## **Public Comments on the Chevron Environmental Management Company**

### **Public Review Draft Final Feasibility Study Report Addendum, August 19, 2024**

Comments submitted by Debora Ashland, Edmonds resident, November 19, 2024

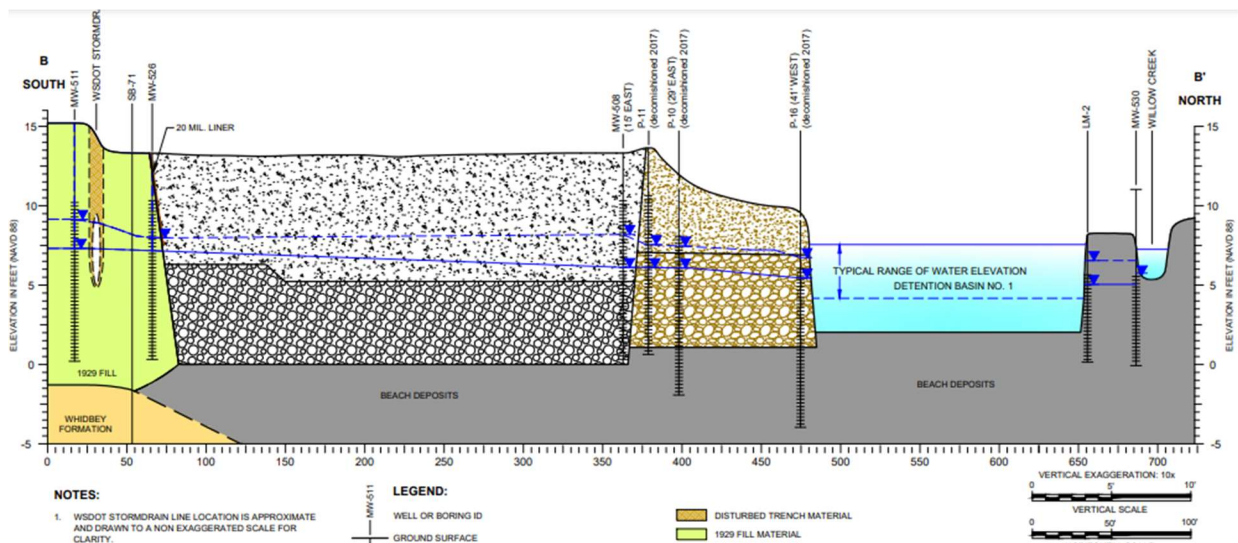
Geotextile fabric is not a long-term permanent solution. The geotextile fabric will degrade over time. Any future use will very likely disturb this system. Therefore, it is not a permanent clean-up scenario. The current Owner of the site needs to clean-up the damage they have done to the site.
